CEA PREVENTIVE ACTIONS FOR XFEL CRYOMODULE ASSEMBLY

Stéphane BERRY completed from Trublet| Thierry at XFEL meeting in 2015 April

COUPLER WARM PART
ASSEMBLY

Coupler Cold Part

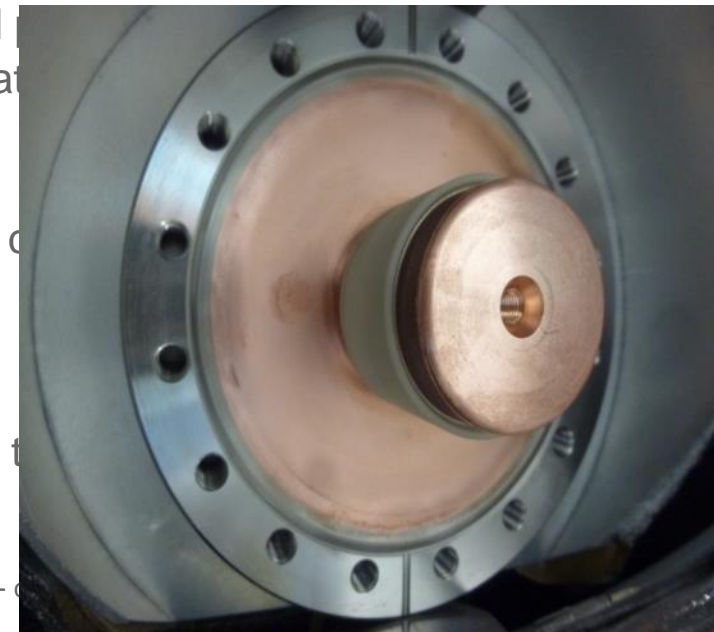
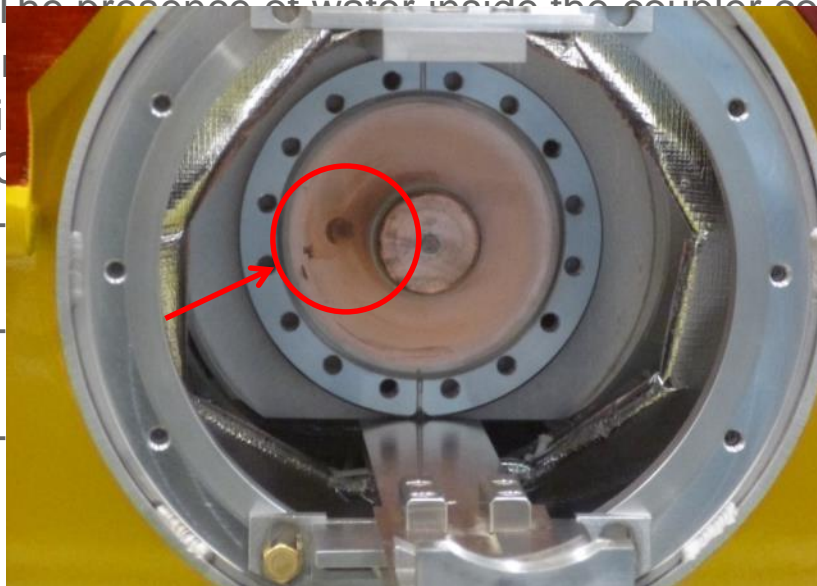
- During the assembly of coupler warm part on the position #4 of XM18 cryomodule, water has been found under ceramic protection cap of coupler cold part THRI-CP-474 (picture 1 on page 2). Some oxidation marks on the coupler cold part copper surface are visible too (left picture).

Coupler Cold Part (FAQ-2015-0398-3C XM48)

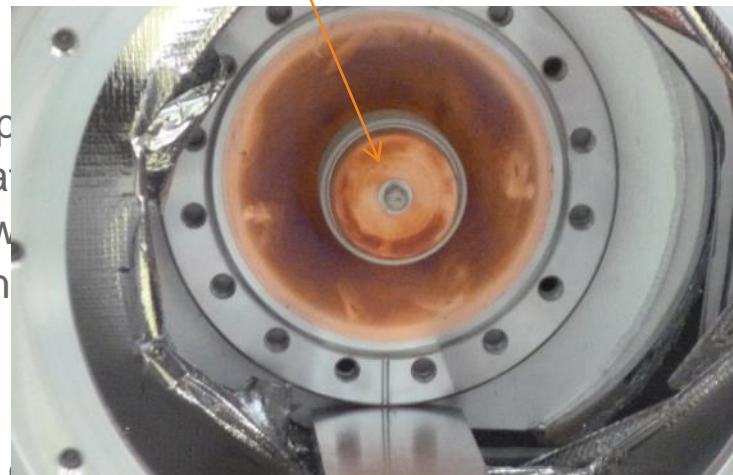
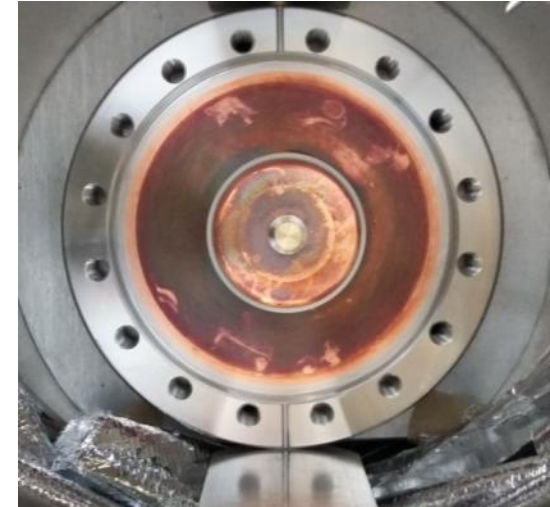
- During the assembly of coupler warm part on several cryomodules, strong coloration of coupler cold part have been found even if we are **not washing** the test wave guide. Some oxidation marks on the coupler cold part copper surface are visible too (left picture). Most of the time the copper **under the RF contact** is not affected.

- Unknown

- clean the copper surface
- them immediately
- The ceramic waveguide
- acid nor ethanol

Coupler Warm Part

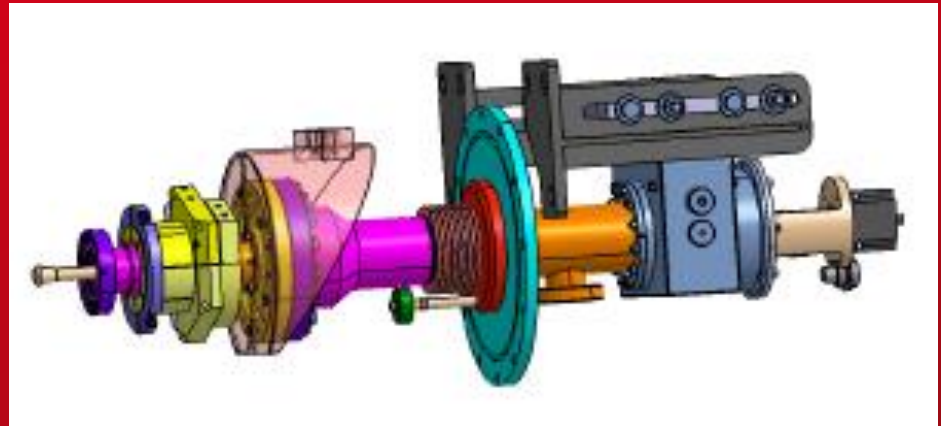
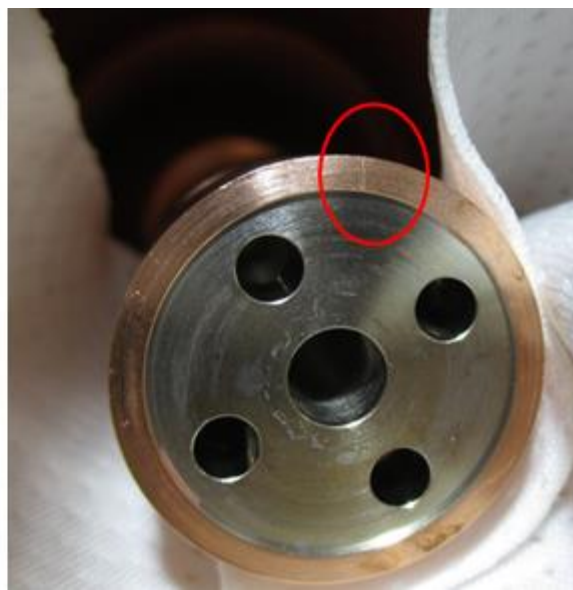
- Issues
 - Scratch on warm part inner conductor (on RF contact)
- Source
 - Disassembly warm from cold part
- Corrective actions
 - LAL: sand paper to remove thickness which risk to compromise the RF contact

No big improvement,
a little bit smoother...

Coupler Warm Part

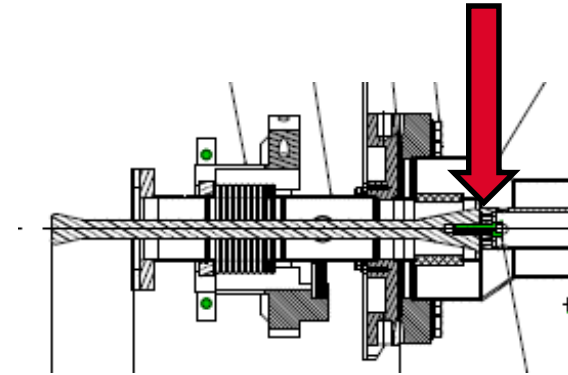
- T70K overheating

- Antenna screw loose

- New material for central screw and new torque (7Nm instead 5Nm)

- Update of instructions file for coupler assembly to take into account the new torque (in addition the number of the turn of the screw is indicated for memory)
- Use of new torque wrench
- Operators awareness to the issue
- Punctual Audit since XM37
